Foster Construction Gravel Excavation

East Lyme, Connecticut

Environmental Review Team Report

May 1996

Site Plan Dated 4/1/96

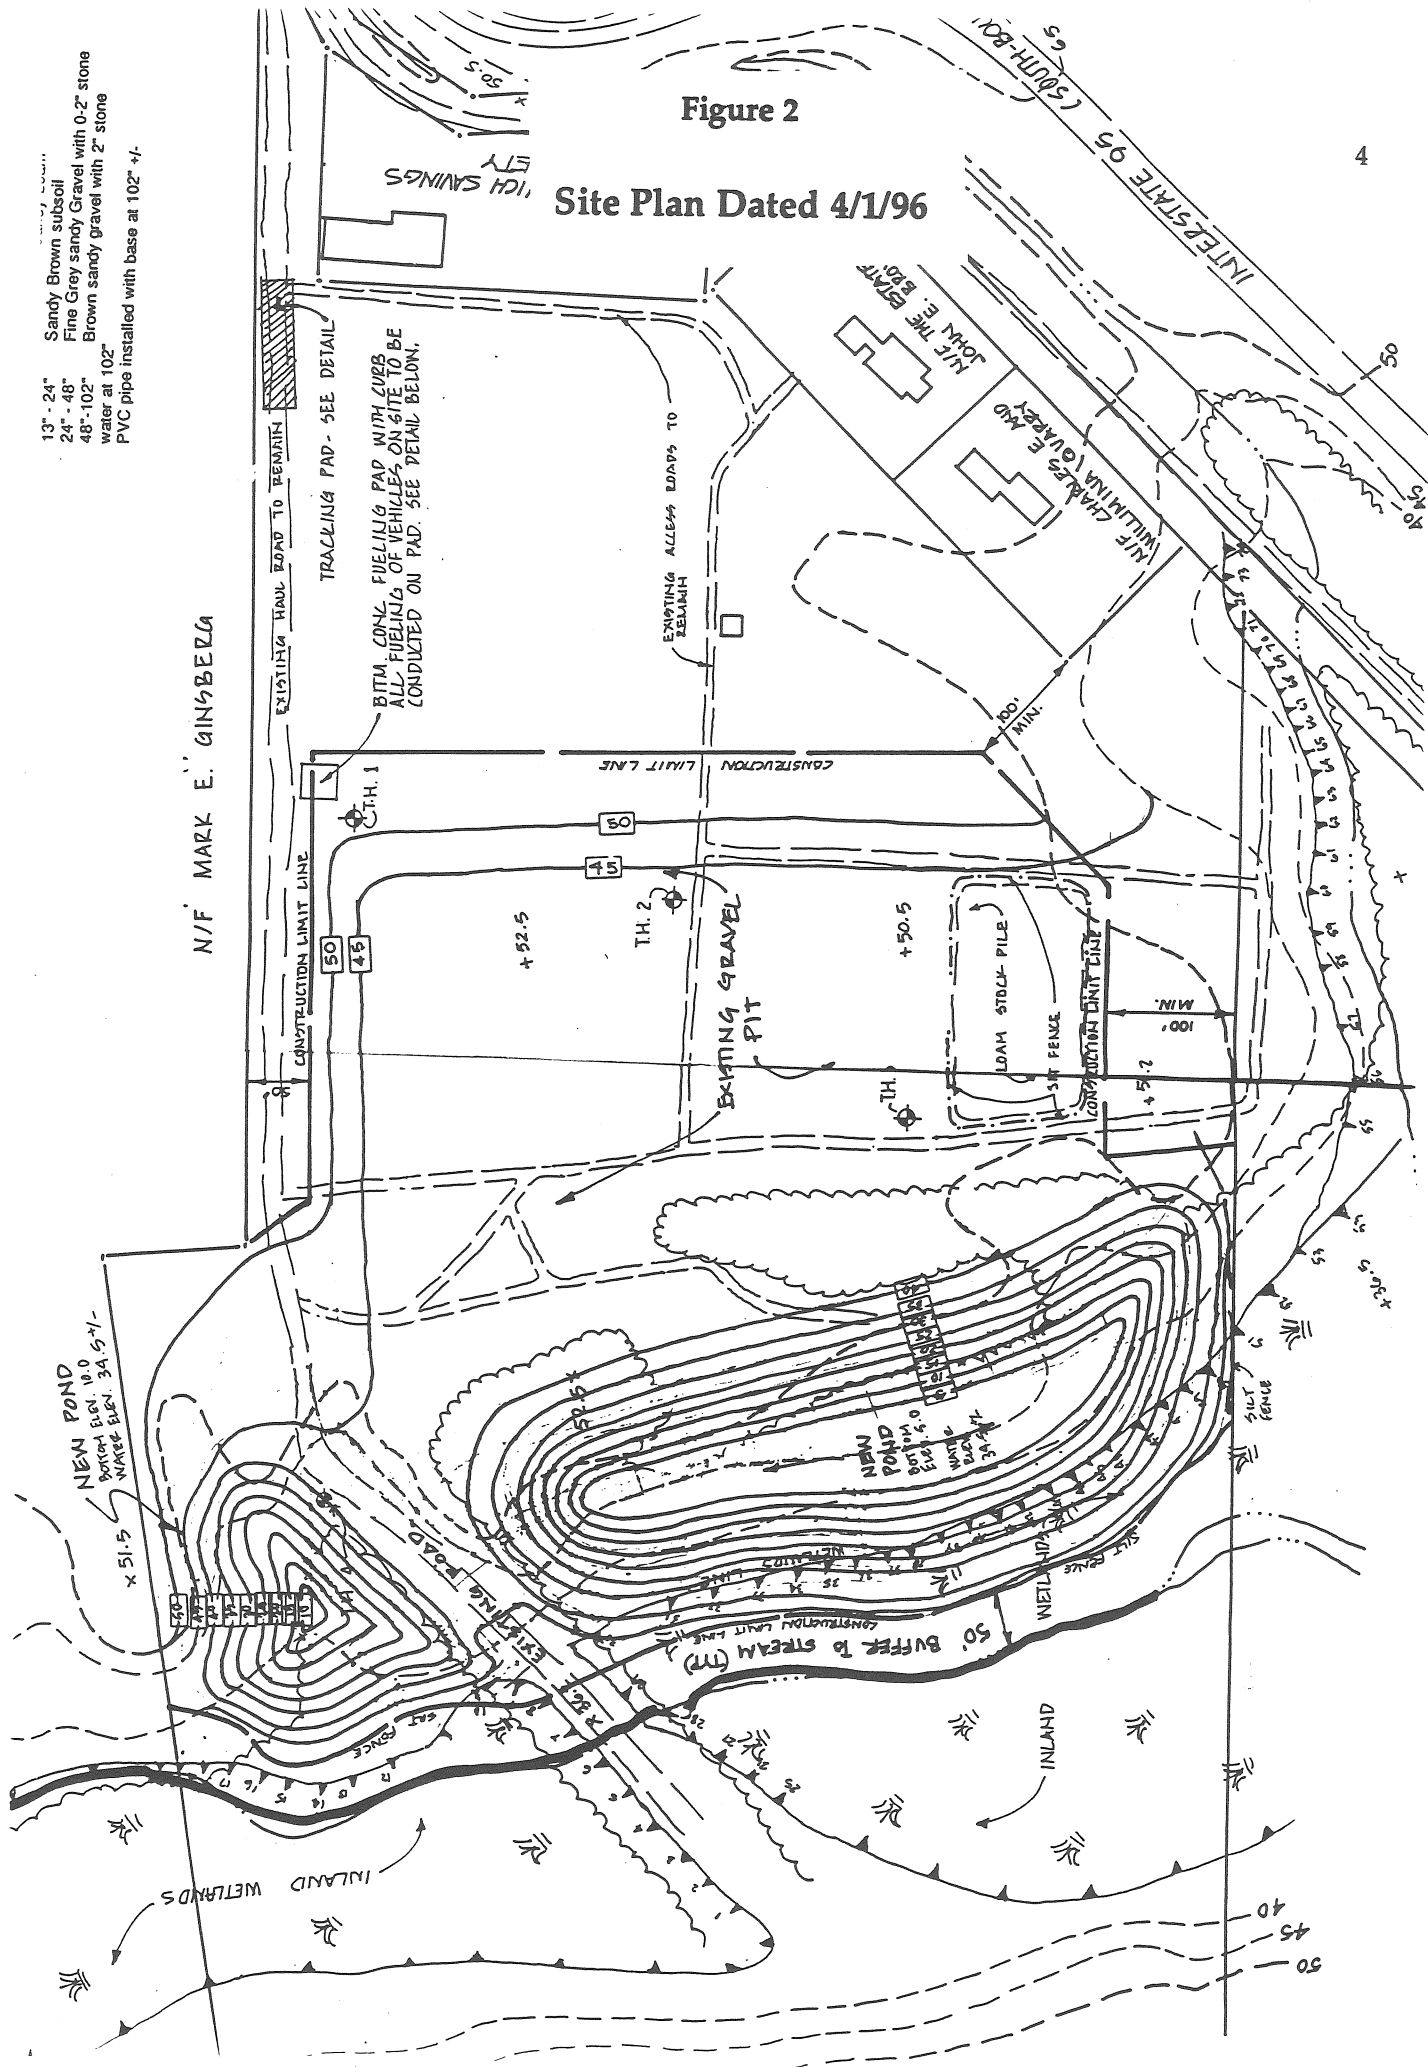
The existing gravel removal permit specifies a finished level surface 6 or more feet above the water table (which has an elevation between 34.5 - 36 feet). The new plans request a permit to excavate two ponds near the boundary with wetlands to the west. The ponds will be dug with a drag line to a bottom elevation of +5-10 feet, removing approximately +180,000 cubic yards of gravel. The excavation will fill with water when the grade falls below the water table. Excavated material will be placed on the ground to drain prior to being sold. Although most of the water will soak into the well drained gravel, several shallow channels observed in the existing gravel surface suggest run-off may occur. Thus the following controls are warranted to protect the adjacent wetland from sedimentation (including siltation).

- **A cloth fence be installed as depicted on plans (dated 4/96) but located along the wetland boundary on the uphill side.**
- **A berm shall be maintained between the pond and wetlands at all times so that the pond may act as a siltation pond during construction.**
- **A grade be maintained behind the pond at the area where saturated dug material will be placed such that any overland drainage will flow into one of the ponds, either completed or under construction.**

The plans presented at the meeting of the ERT field review (5/9/96) had been substantially revised from the initial proposal, resulting in a significant reduction in impacts to the Pattagansett River and the adjacent wetlands. In the new proposal excavation will end at the flagged wetland line, or 50 feet from the river, whichever is further. The wetland - upland edge will be converted to wetland - open water edge.

Detailed elevations are not shown on the plan. The edge of the south pond (at edge of wetlands) is at an elevation of approximately 39 feet. The 50 year flood elevation in this area is about 39.5 feet, thus the pond will be inundated by floodwater for this and larger storm events. This could introduce sediment, debris and nutrients into the ponds.

It would be beneficial to include lime, fertilizer, mulch, and seed types and rates on the plan. The plans state that inactive areas will not be left unprotected more than three weeks. Areas seeded during the summer months may require irrigation. Temporary mulching may be required during winter months.

The plans do not include a disposal procedure for cleared material.

Two ponds are proposed to be built on the site as part of an on-going gravel extraction operation. According to the plan entitled "Proposed Topsoil and Gravel Extraction on the Land of ... Bower/Flanders Road, East Lyme, Connecticut, sheet 1 of 1, dated 4/01/96; the ponds encroach on the east side of the wetland corridor which runs north to south, directly impacting 0.5 acres of the wetland. However, verbal indications by Mr. Robert Foster, the applicant, during the ERT review meeting are that the proposed plan will be revised so that there is no direct impact (excavation or filling) to the wetland area.

A statement should be included on the plan that Connecticut's Guidelines for Soil and Erosion and Sedimentation (E&S) Control will be used as a general reference on E&S matters. Given that these are "dug ponds" with no embankments, inlets or outlets, the possibility of severe erosion and sedimentation (E&S) is significantly reduced. It is recommended that excavation take place so that water will drain into the middle of the developing ponds at all times. The silt fence should be placed approximately 10 feet "up slope" of the wetland limit to allow room for installation and maintenance of these barriers. Mention of the process for de-watering of the excavated pond sediments should be included on the plan as well as methodology for de-watering the pond during construction (if planned).

The 100-year flood boundary and floodway boundary should be included on the plan, with reference as to their source and accuracy. It appears that the excavation will take place outside of the floodway, where higher velocities and volumes are conveyed during flood events, but well inside of the 100-year floodplain. Pond perimeters should be designed to withstand expected velocities during flooding events.

The other obvious source of pollution would be a release of fuel, oil, hydraulic fluid, etc. from the excavating equipment. The plans call for a refuel pad and one was observed in the field, however it was not completed according to plan detail, with curbing. Additionally, it appears that the pitch of the pad would allow spilled fuel to flow past the uncurbed portion of the pad. The applicant also indicated that major equipment repair does not occur at this site. This condition should be placed on the plan as well as a short "spill contaminant response plan."

Finally it is recommended that the following items be added to the plan:

- an erosion and sedimentation control narrative including the basic principles to be followed and discussion of any potentially serious erosion and sedimentation problems,
- a locus map of the project at the scale of 1" = 2000', including project limits, north arrow, street names, major drainage ways and watershed limits (if any),
- a signature of the soil scientist certifying the accuracy of the wetland boundary,
- references for the horizontal and vertical control, property lines, floodplain boundaries, inland wetland boundaries, etc.,
- location, size and variety of notable trees,
- maintenance requirements of temporary measures during the construction period
